Reference: Engineering Services
50 Otto Rd.
Lillington, NC 27546
TE&D Project No.: DRB2301-0466_B

As requested, a representative of Tyndall Engineering & Design, PA (TE&D) was on-site to observe the following items:

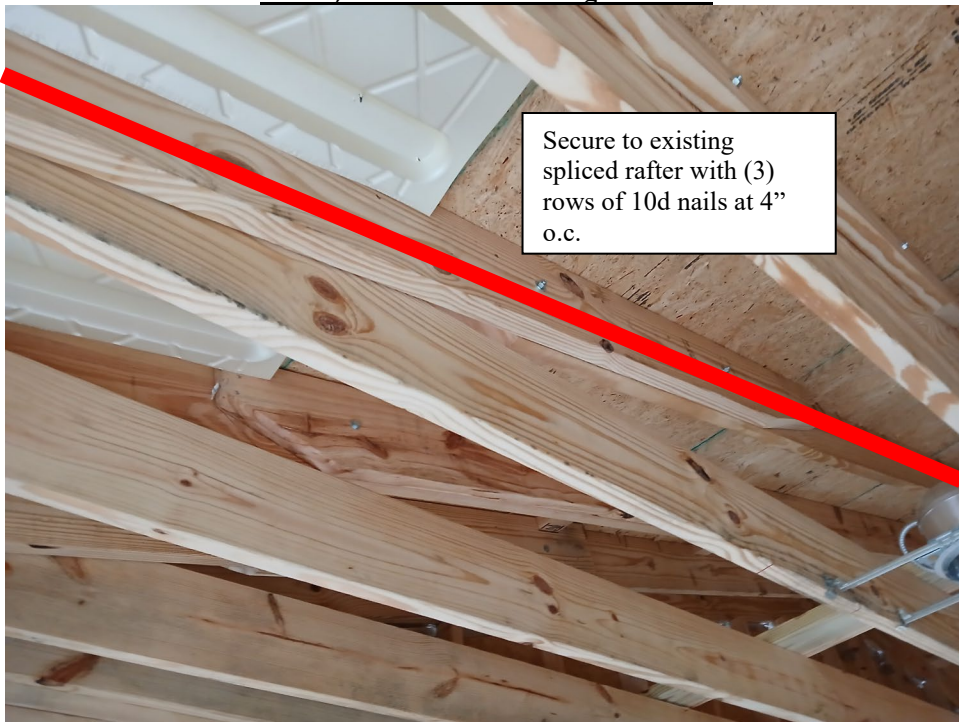
1. We observed a (2) 2 x 10 beam spanning left to right supporting the ceiling of the addition was installed in lieu of the (2) 1-3/4" x 11-7/8" LVL specified in the structural plan. Based on our observations and analysis, the existing configuration is inadequate to support the anticipated loading conditions. TE&D recommends replacing the existing beam with a (2) 1-3/4" x 11-7/8" LVL per plan.

2. We observed the rafters were spliced with an approximate 7'-10" long member at the lower end. Based on our observations and analysis, the existing configuration is inadequate to support the anticipated loading conditions. TE&D recommends installing new continuous 2 x 8 rafters at 16" o.c. spanning from the ridge to the exterior wall. The new rafters are to be fastened to the existing lower portion of the rafter splices with (3) rows of 10d nails at 4" o.c. 2 x 4 collar ties are to be fastened to the new rafters at 32" o.c.

3. We observed a (2) 2 x 10 girder spanning left to right supporting the floor at the center of the addition was installed in lieu of the (3) 2 x 10 girder specified on the plans. Based on our observations and analysis, this configuration is adequate to support the anticipated loading conditions. No further modification is required.

4. We observed the floor of the addition was framed with 2 x 10 joists at 16" o.c. spanning up to 14'-8". Based on our observations and analysis, the existing configuration is inadequate to support the anticipated loading conditions. TE&D recommends sistering an additional 2 x 10 joist to every third existing joist.

Item 1) Install (2) 1-3/4" x 11-7/8" LVL Per Plan.

Item 2) Install New Full-Length Rafters

Item 3) Girder Analyzed.

Item 4) Double Every 3rd Joist
